ADDENDUM NO. 1

Renovate Sub (Acid) Lab Missouri Geological Survey (DNR) Rolla, Missouri

PROJECT NO.: W2001-01

CODE PLAN AND REVIEW PLAN

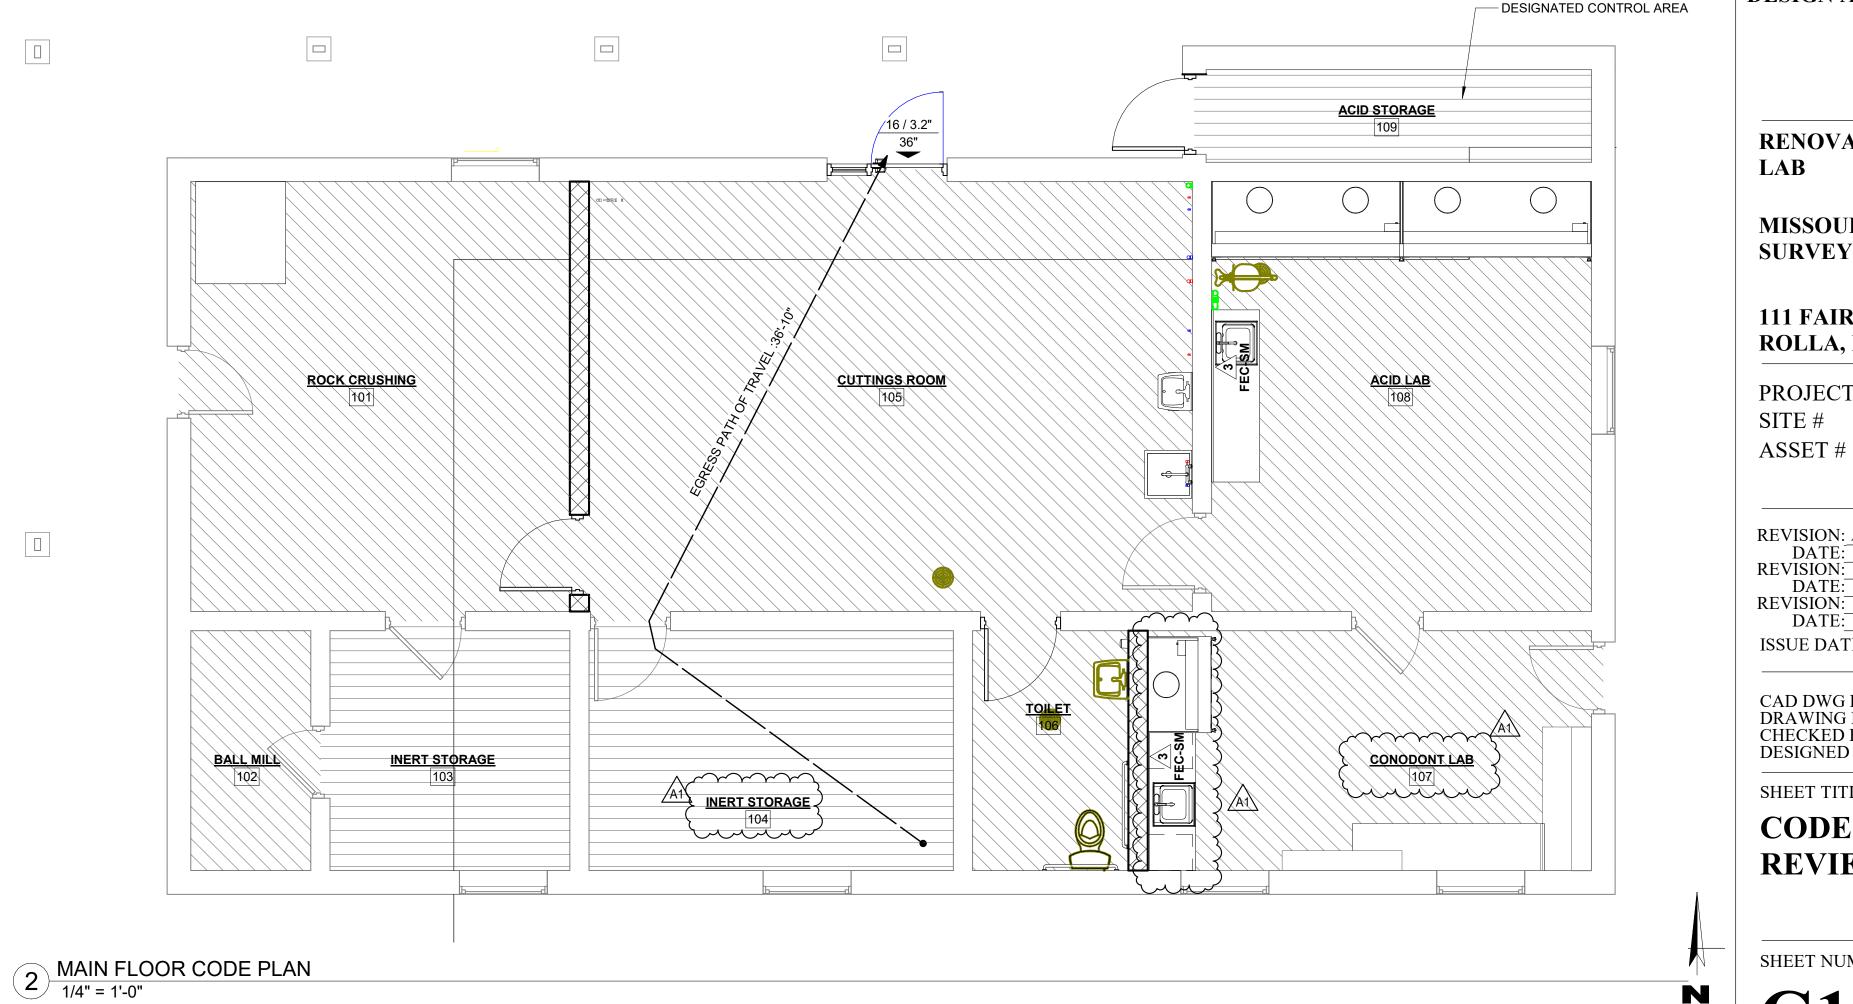
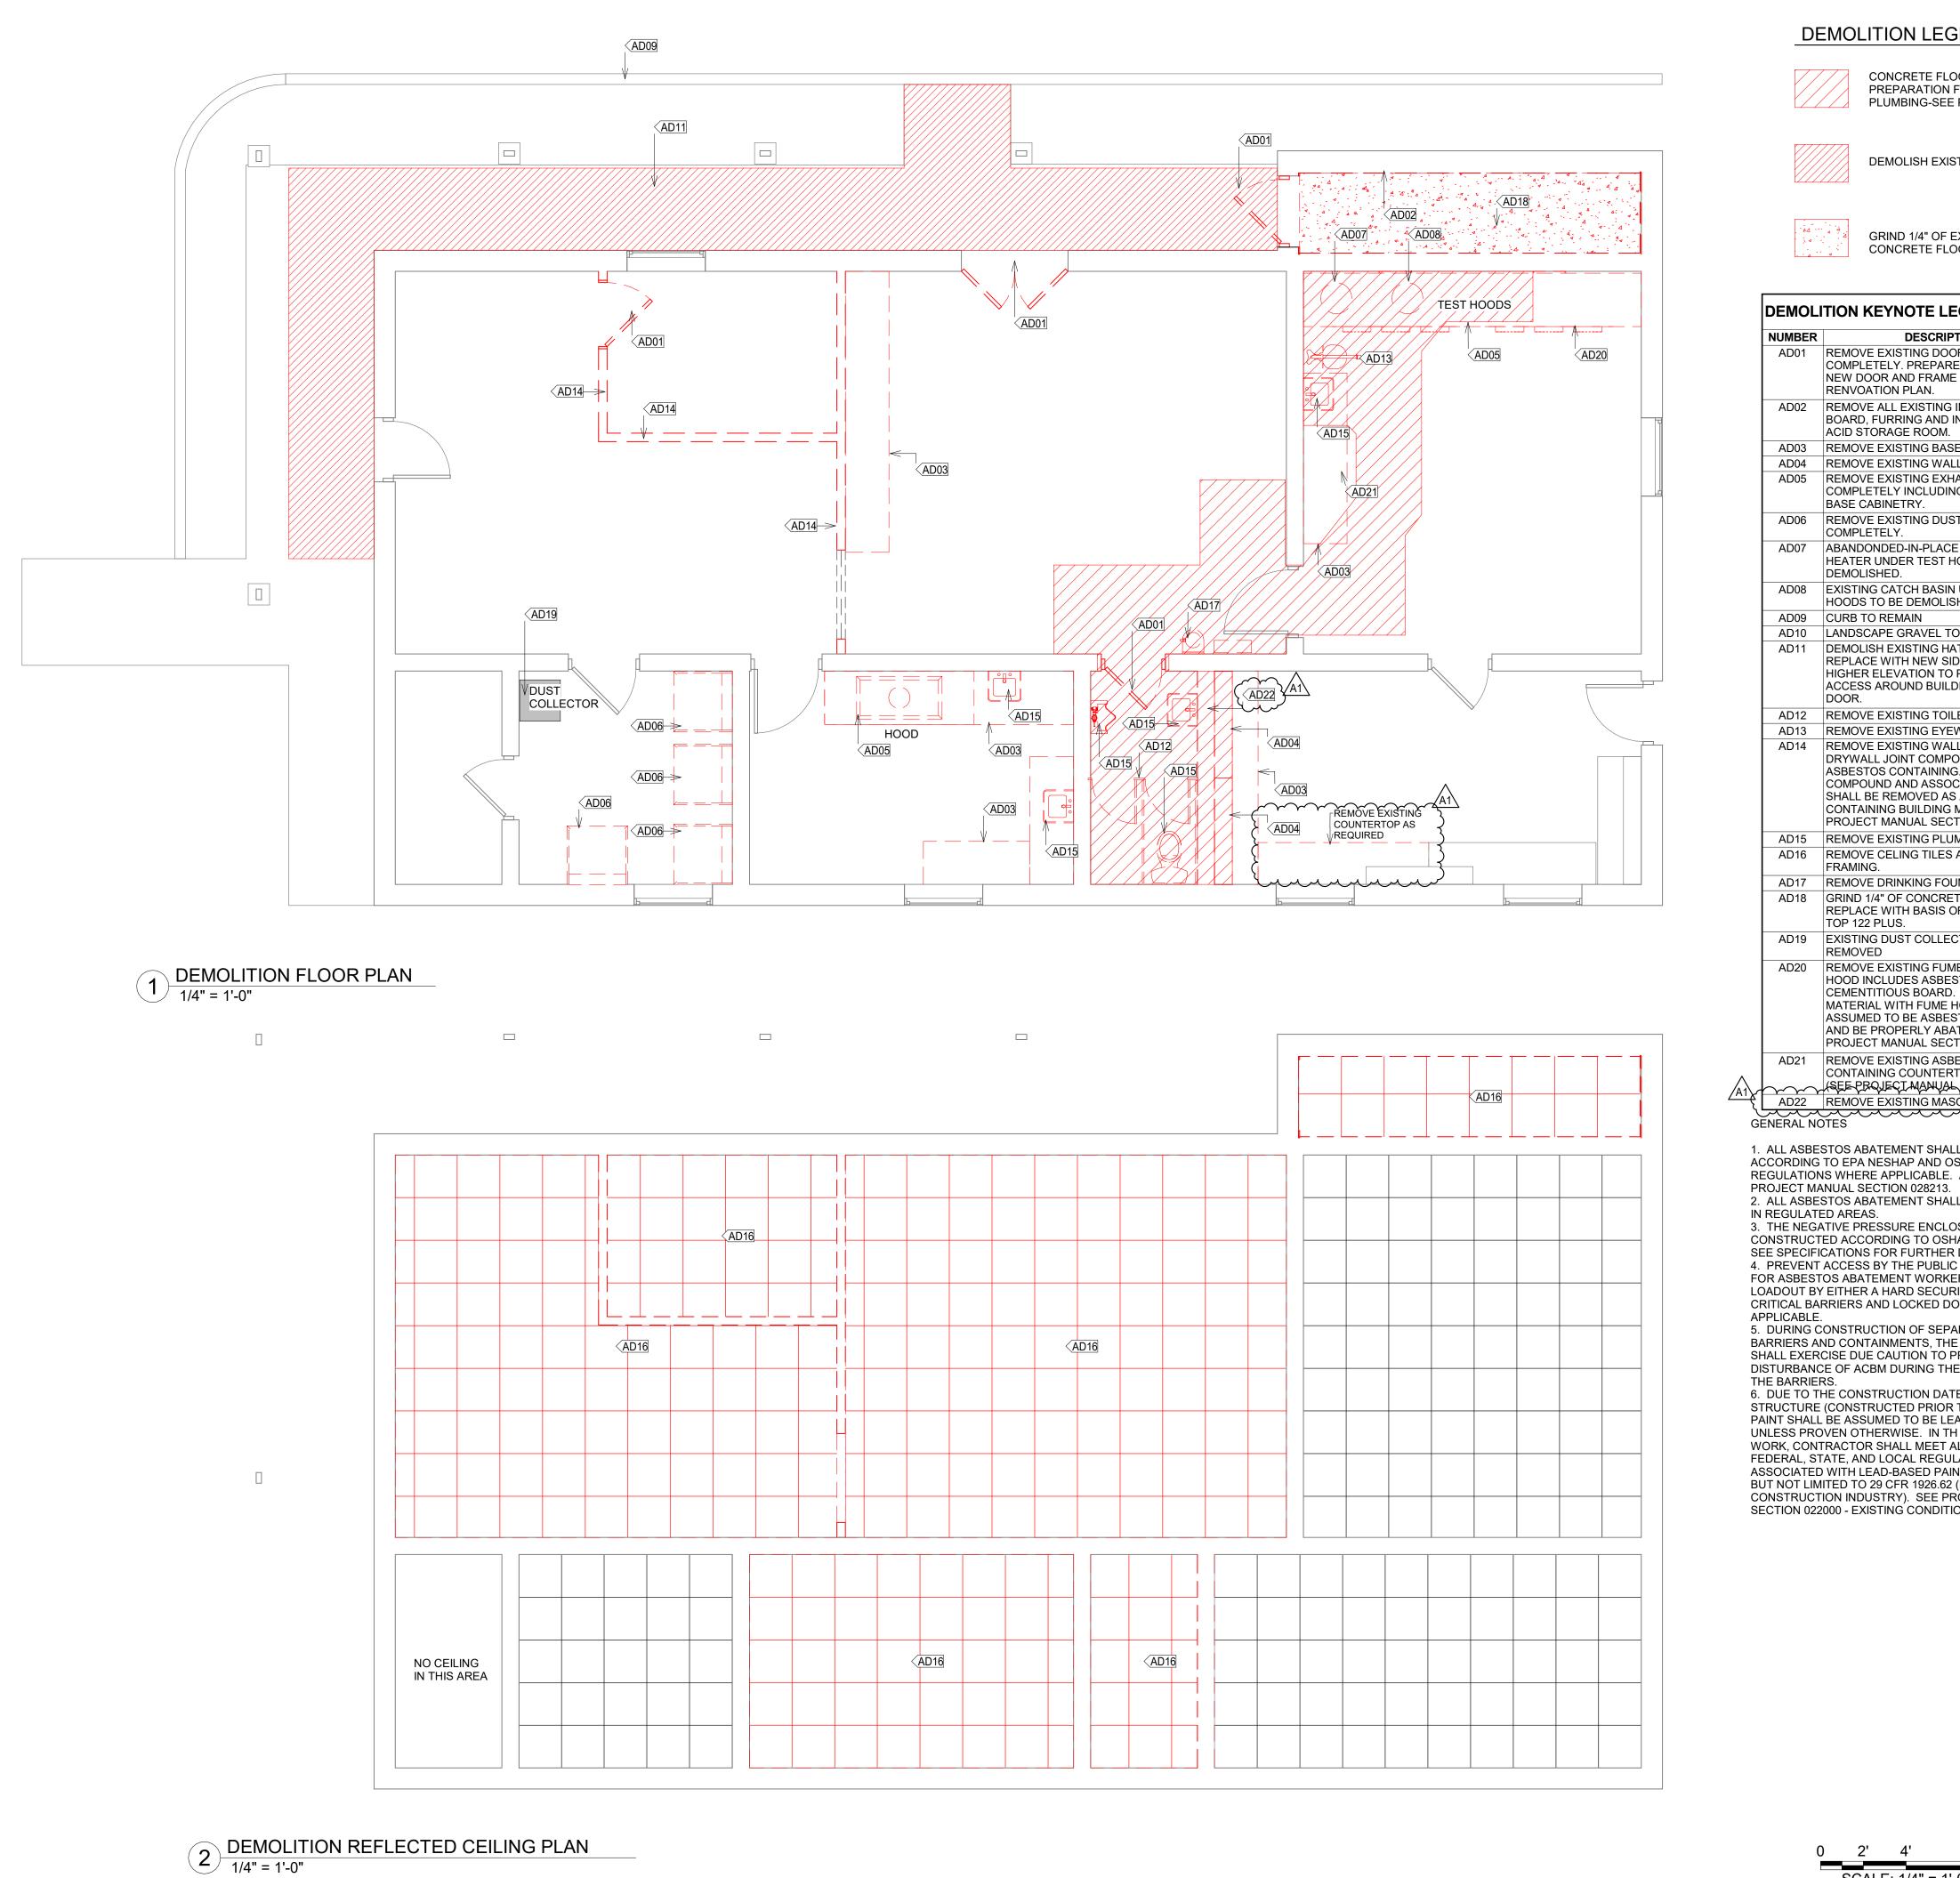
- a. REVISE Room 104 name to Inert Storage and Room 107 to Conodont Lab
- b. REMOVE Hood and Cabinetry from Room 104
- c. ADD Hood and Cabinetry to Room 107
- d. Revised sheet is attached.

## **DEMOLITION FLOOR PLAN**

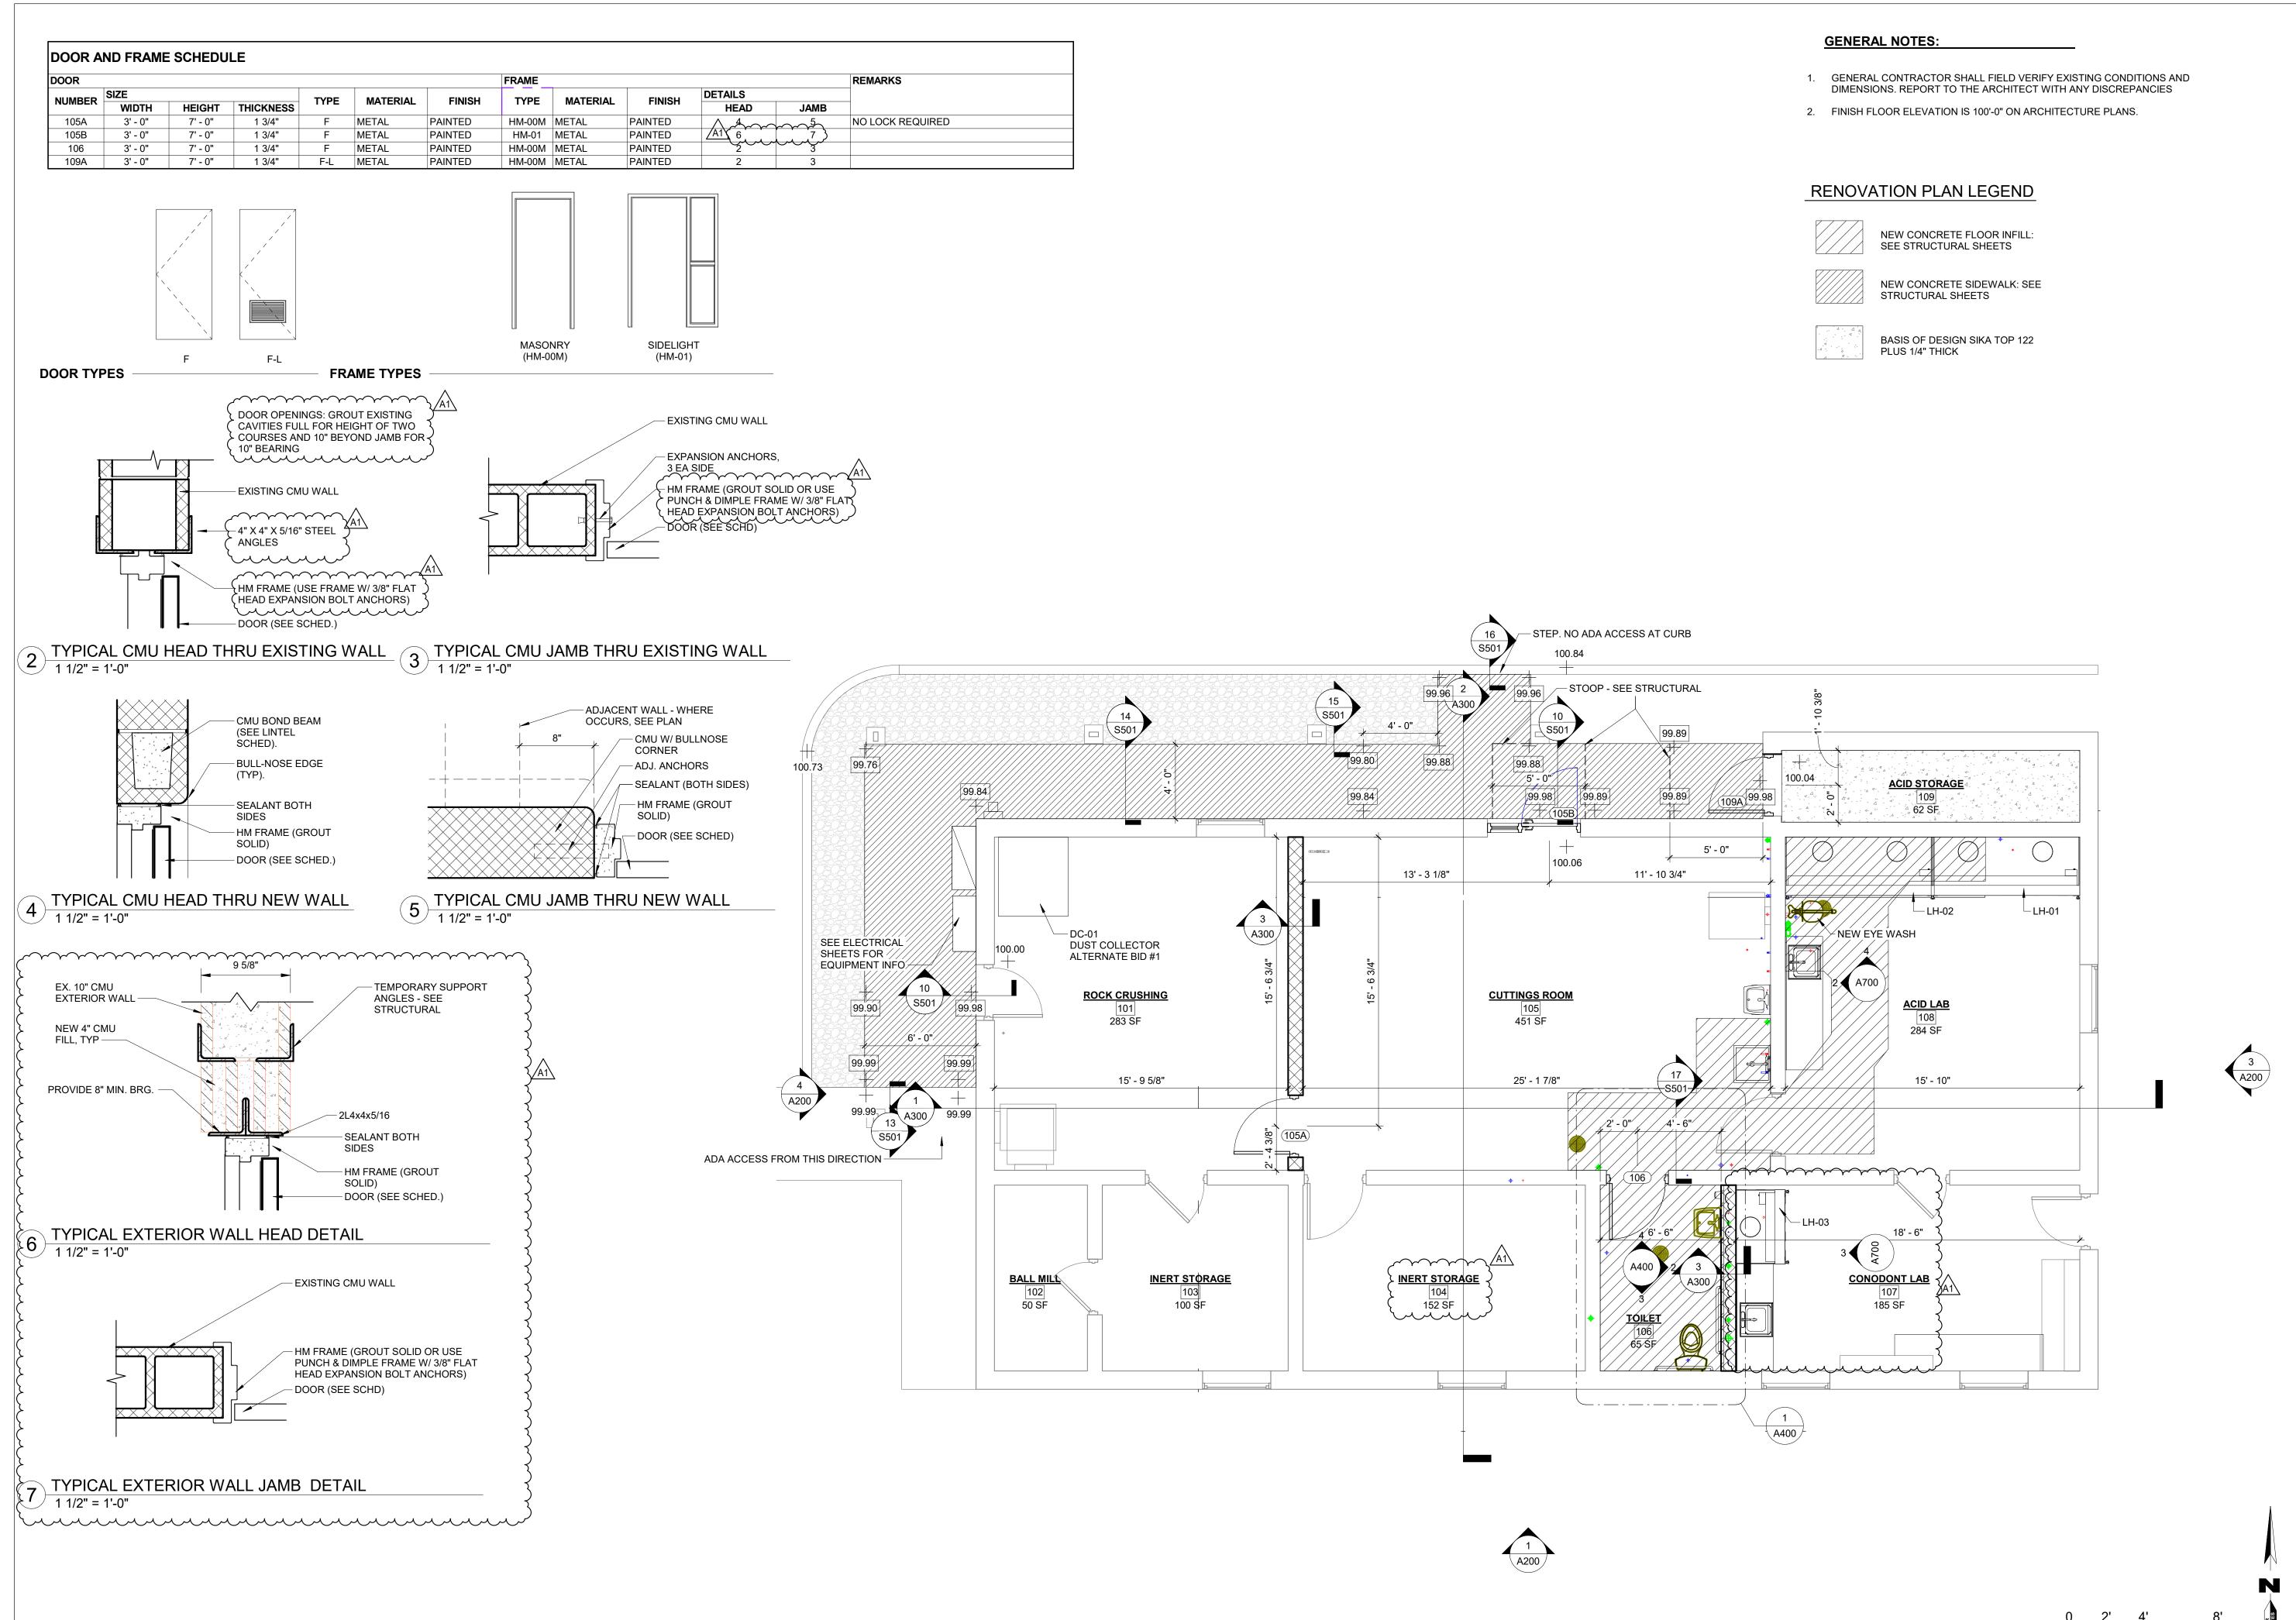
- a. ADD Keynote AD22 Remove existing Masonry Wall.
- b. REVISE Demolition Floor Plan to remove existing countertop
- c. Revised sheet is attached.
